LOCALITY	Mossman and Environs
PLANNING AREA	Residential 1
PLANNING SCHEME	Douglas Shire Planning Scheme 2008
REFERRAL AGENCIES	State Assessment and Referral Agency
NUMBER OF SUBMITTERS	Not Applicable
STATUTORY ASSESSMENT DEADLINE	Expired (23 December 2015)
APPLICATION DATE	14 January 2015 (Original Application) 3 November 2015 (Changed Application)

That Council approves the development application for a staged Reconfiguring of a Lot over land described as Lot 113 on SP213765, located at 12-36 Alchera Drive Mossman, subject to the following:

Drawing or Document	Reference	Date
Stage Plan	Brazier Motti Job 31122/42-1 Drawing 31122/119 G dated 3 November 2015 and to be amended by the conditions of the approval	To be Determined

Attachment 4—Approved plans and specifications

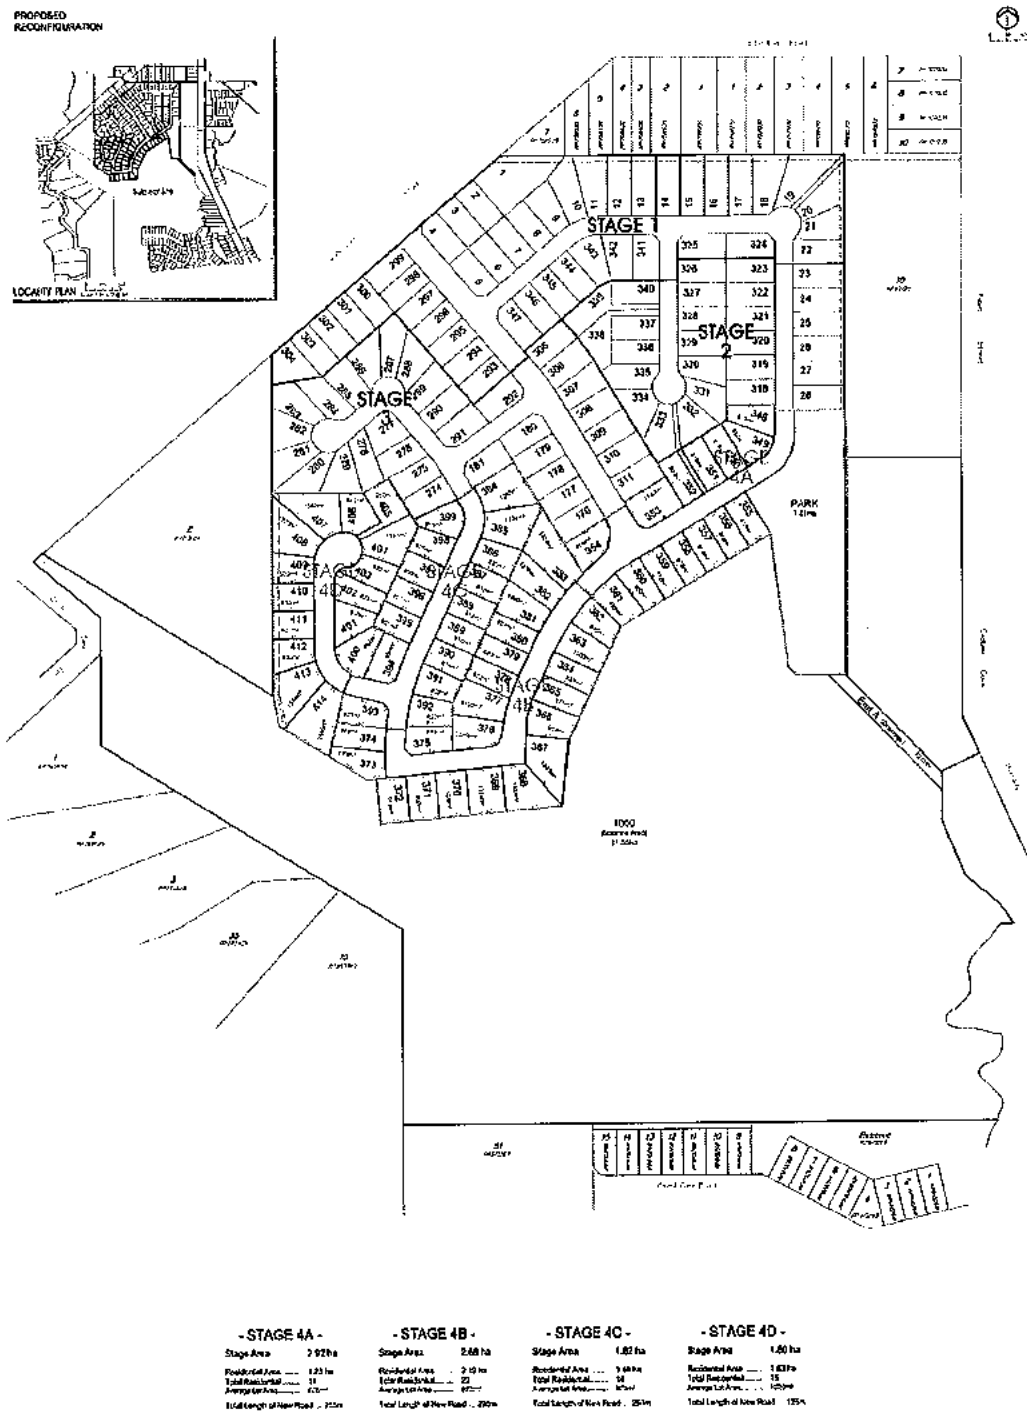
4. The lot reconfiguration layout as shown on Drawing 31122/119 G must be amended to provide:
 - a. road access to balance Lot 1000 in minimum of two locations (nominally opposite Lot 349 in Stage 4A and an extension to Daintree Horizons Drive nominally in the vicinity of Lot 368 in Stage 4B). The extension to Daintree Horizons Drive is to be designed to be suitable for buses in accordance with the FNQROC Development Manual;
 - b. The location and configuration of the park as shown in Stage 4A is not approved. A centrally located area of park is to be provided within the estate to provide a centre-piece for the estate and to adequately cater for the existing stages (1, 2 and 3) and remaining stages of the estate. The park is to be provided with substantial road frontage. A minimum of 10% of the entire estate area (i.e. all stages inclusive) is to be provided as park.

The current layout as shown on Plan Ref: 31122/119 G provides 1.21 hectares of parkland as part of Stage 4A of the proposed development. The proposed location of the parkland is not in accordance with that envisaged when the overall concept plan for the Daintree Horizons Estate was approved in association with CA57. Furthermore, the proposed park location and shape is not practical or desirable.

The current layout as shown on Plan Ref: 31122/119 G no longer provides the road link that will connect Johnston Road to the estate of Forest Glen Drive that was originally proposed as part of the original master plan for the estate. The proposed connection is desirable from a planning and traffic perspective and was originally conditioned to include provision for a bus stop. The layout must be amended to show that a future connection through the balance lot to the estate off Forest Glen Drive is not compromised by the proposed subdivision. The connecting road will need to be of a suitable width to accommodate the future volume of traffic that the road is expected to carry.

An amended plan showing the above amendments must be endorsed by the Chief Executive Officer prior to the issue of a Development Permit for Operational Works.
